CITY OF KIRKLAND
Planning and Building Department
123 Fifth Avenue, Kirkland, WA 98033
425.587-3600 - www.kirklandwa.gov

File No.: DRV18-00493

Subject: **ROSE HILL MIXED USE PROJECT CONCEPTUAL MASTER PLAN AND PROJECT DESIGN RESPONSE CONFERENCE**

DRV18-00493
ATTACHMENT 2

2 REVISED ELEVATION - VIEW FROM 85TH ST

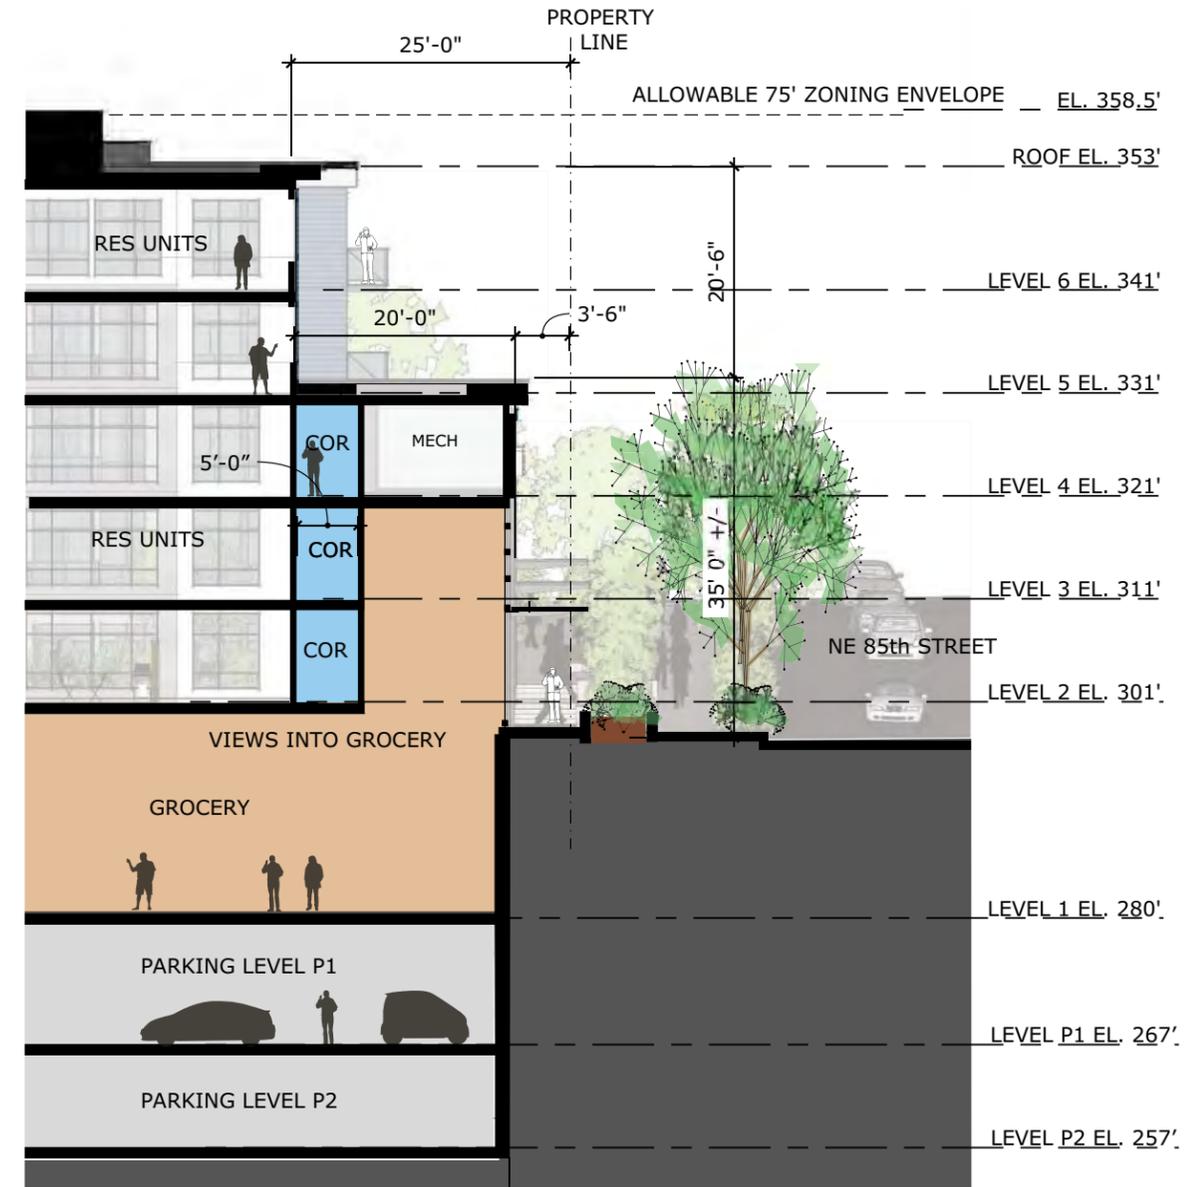
At the December 3rd Meeting, the DRB was accepting of the overall massing, detailed elevations and material usage, but the Board requested that the applicant address the following items:

- Different options for design of the NE 85th Street Façade for Building D.
- Reduced heights of planters along NE 85th and stepping down of weather protection along NE 85th Street.
- More detailing needed along Building D Façade adjacent to U-Haul site.
- Explore more parapet and rooftop modulation along longer façade including the north elevation of Building B.
- Revised landscaping plan to include more variety and interest.
- Provide additional details of service and loading area designs.

MORE RESIDENTIAL WINDOWS FACING 85TH WITH BALCONIES WRAPPING CORNERS

PLANTERS STEP DOWN WITH GRADE

CANOPIES STEP DOWN WITH GRADE FOR WEATHER PROTECTION
